Proposed Residential Development, Kingsway, Burnage

Highways Technical Note

Response to Highways Comments from Manchester City Council and Transport for Greater Manchester

31st January 2025

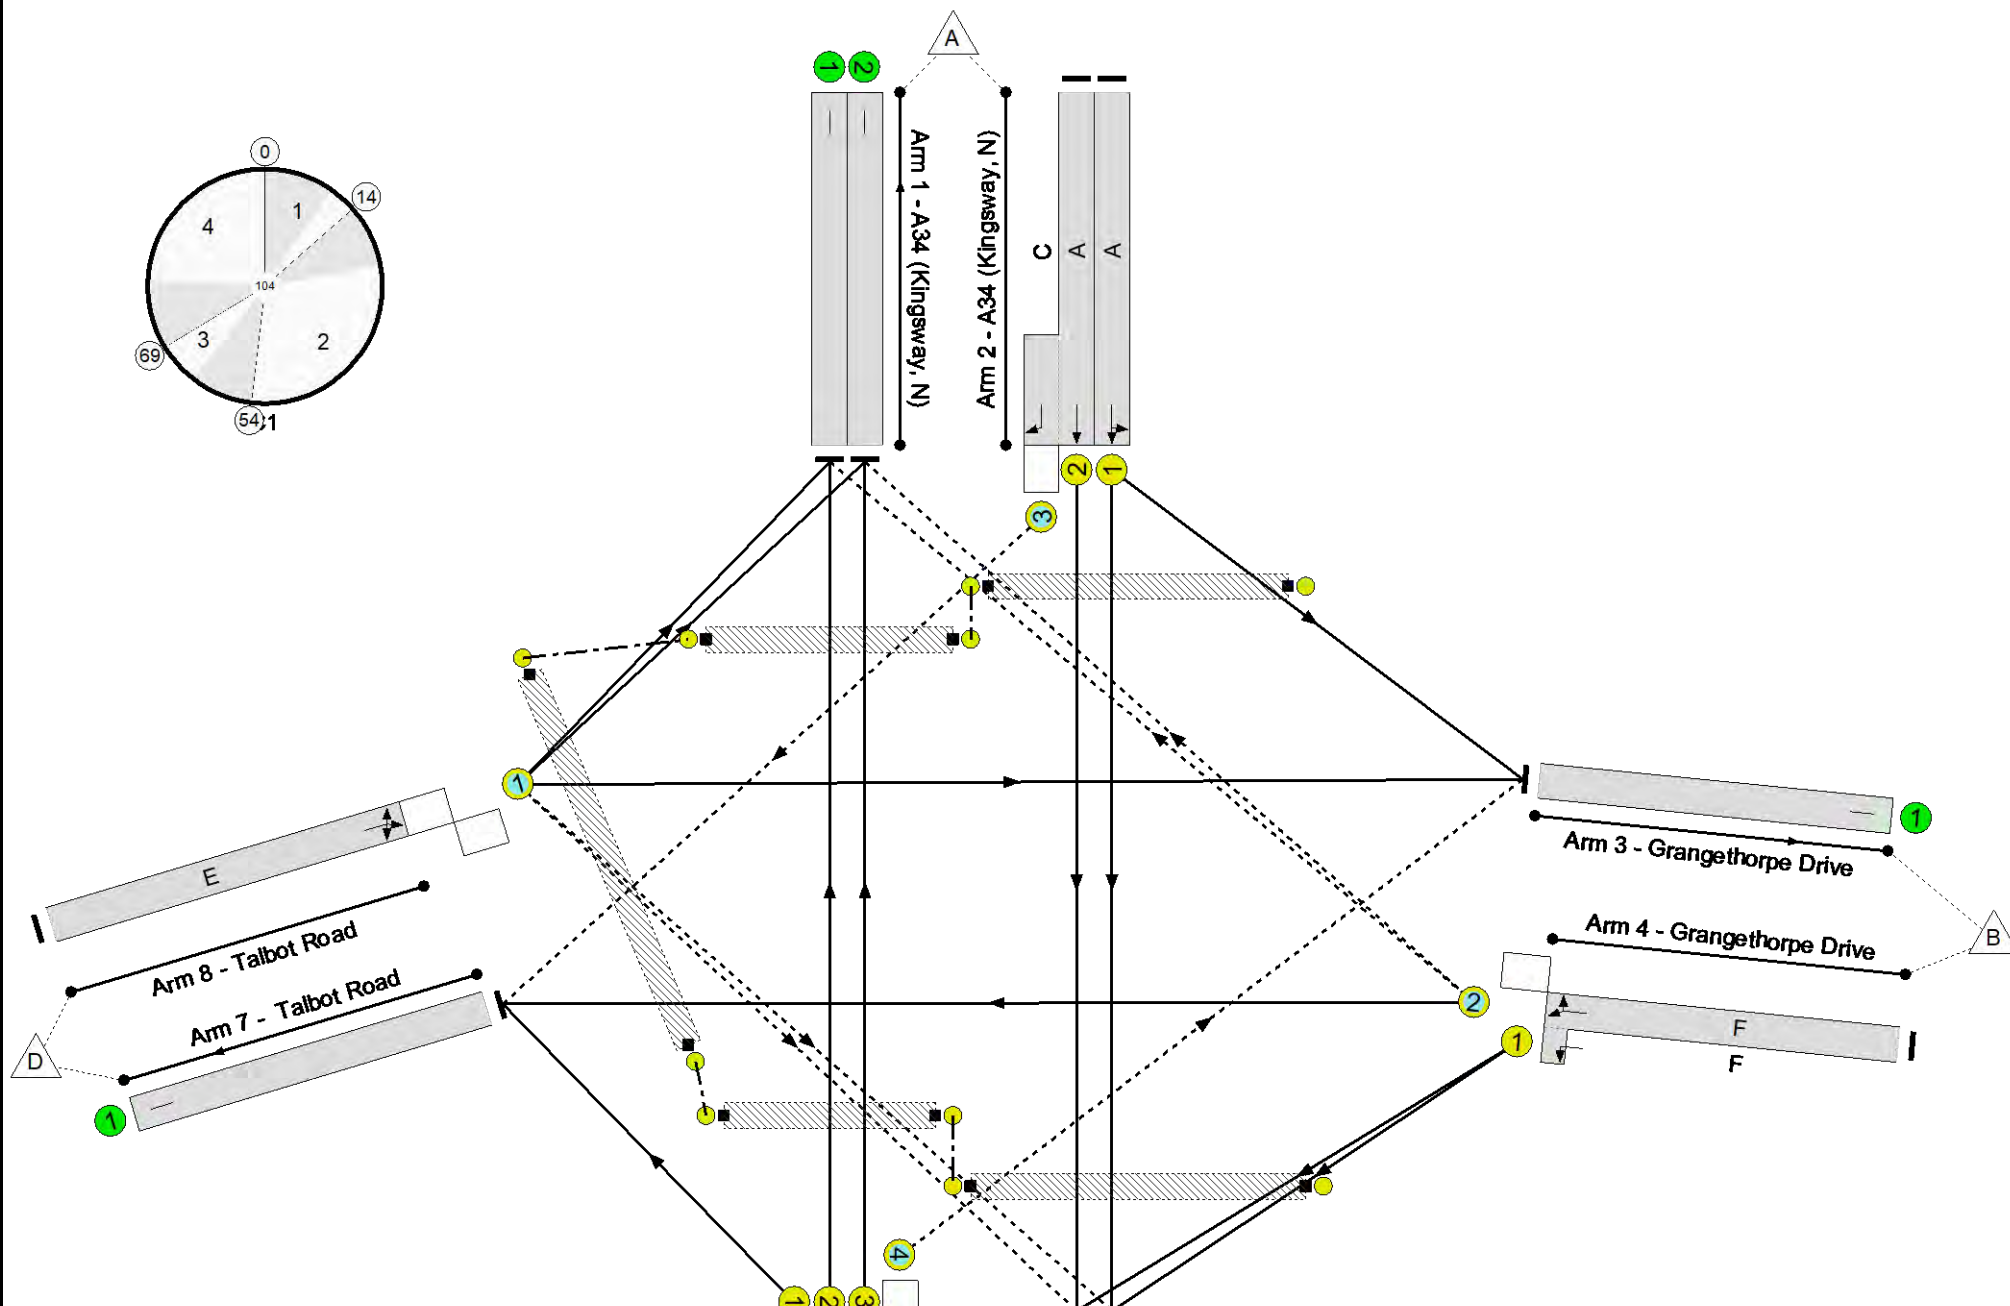
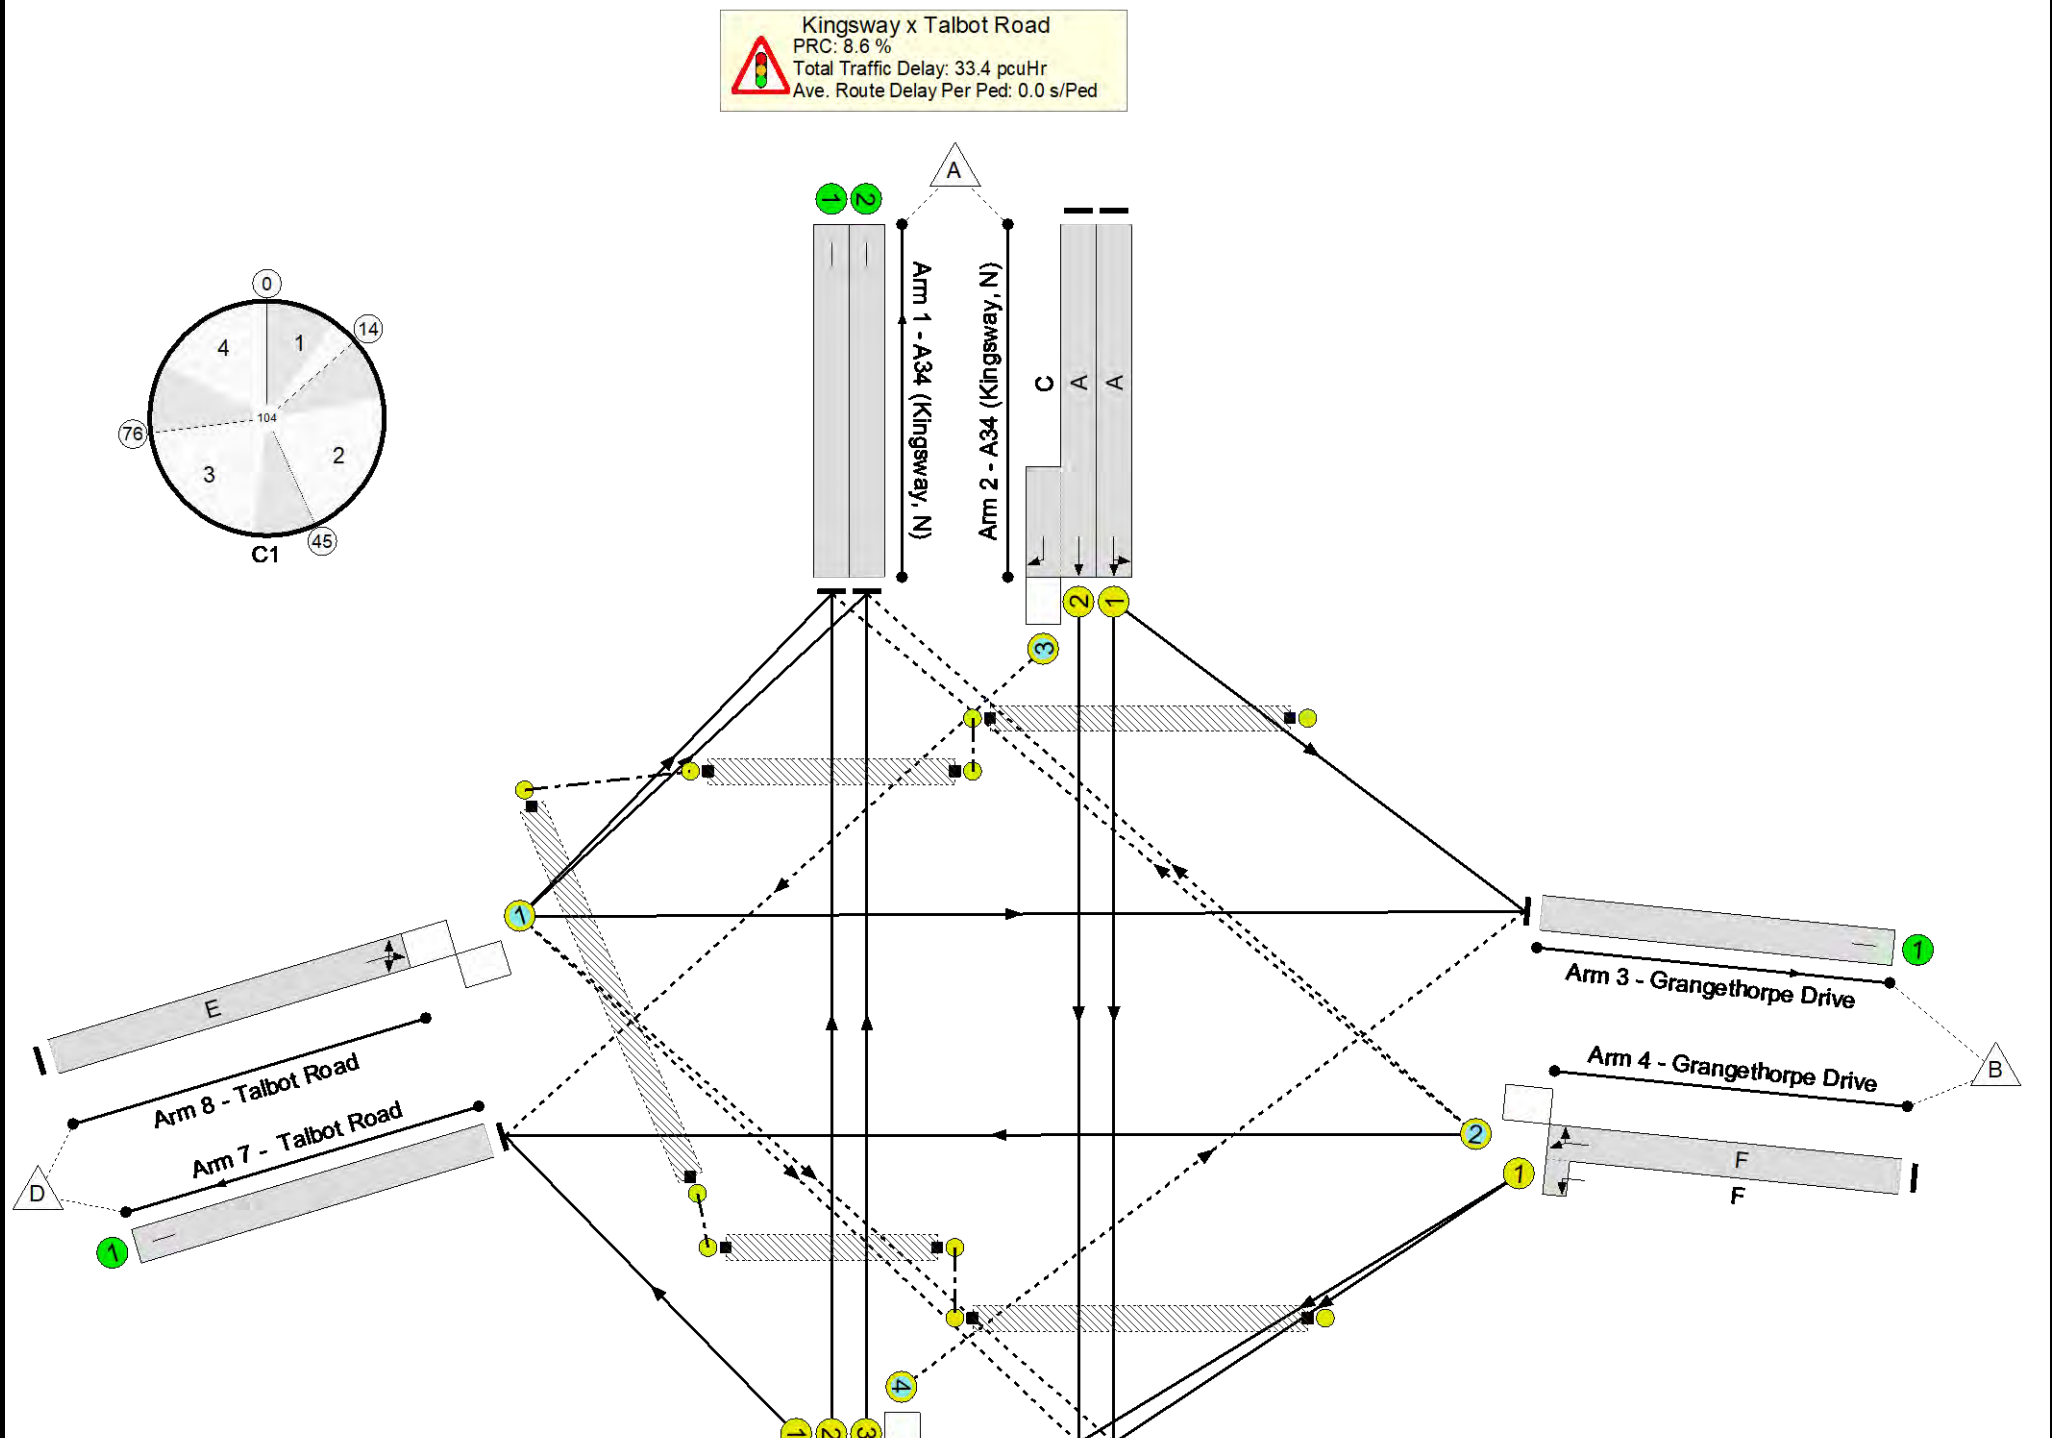
The TA includes a netting off exercise whereby the existing trips for the B&M store are removed from the new development trip totals. The two developments are not similar in nature. For a residential development there will be more trips leaving in the morning and more trips returning in the afternoon due to commuting, compared to a store where the arrival and departure pattern is likely to be more even during the day. Therefore the discounting of trips is not agreed as the tidal nature of the trips will be different. It is likely that some trips will be removed from the network as a result of the store closing. It is suggested that a sensitivity test is run which allows for the netting off of 50% of the B&M store trips from the new development trips rather than the full 100%. This could be classed as a worst case scenario. It is also queried whether the distribution will be 50:50 north and south out of the site.

The TA states that pedestrian facilities will be provided across Talbot Road, but this isn't shown (clearly) on the proposed layout and it is unclear how this will be achieved. If the intention is to take the crossing from the triangular island between Talbot Road and Kingsway south, the island will need to be enlarged to accommodate the signal equipment and correct configuration of tactile paving. It is also unclear if the footway on the southern side of Talbot Road between Kingsway and the access road will be improved. It is recommended that it is widened, the bushes cut back and the speed restriction sign be relocated from the centre of the footway. The footway round the radius from Talbot Road onto Kingsway south should also be widened. In order to fully assess the modelling work, the LINSIG files should be supplied.

A traffic survey of the existing B&M store was carried out on Tuesday 6th June 2023. The existing B&M trips have been netted off for the peak hours associated with the residential development, thus representing a like for like assessment of traffic flows in the AM and PM peak hour, respectively. However, to assess a worst case scenario as suggested by MCC / TfGM, a sensitivity test has been undertaken which nets off just 50% of the existing B&M trips. The modelling results are demonstrated in [Table 1](#) below.

The sensitivity test has shown the junction to operate within its capacity, all approaches would operate with a modelled DoS that is below 90%, and all queuing is accommodated without any significant or adverse impacts on the wider network in accordance with the NPPF.

Once the signalised crossing of Talbot Road is included the junction is still expected to still operate better than the 2029 Do Nothing scenario. Queues on the A34 Kingsway are still expected to reduce.

Therefore, the sensitivity test has shown that even with netting off only 50% of the existing trips to the site the proposals are still expected to have a beneficial impact on the operation of this junction.
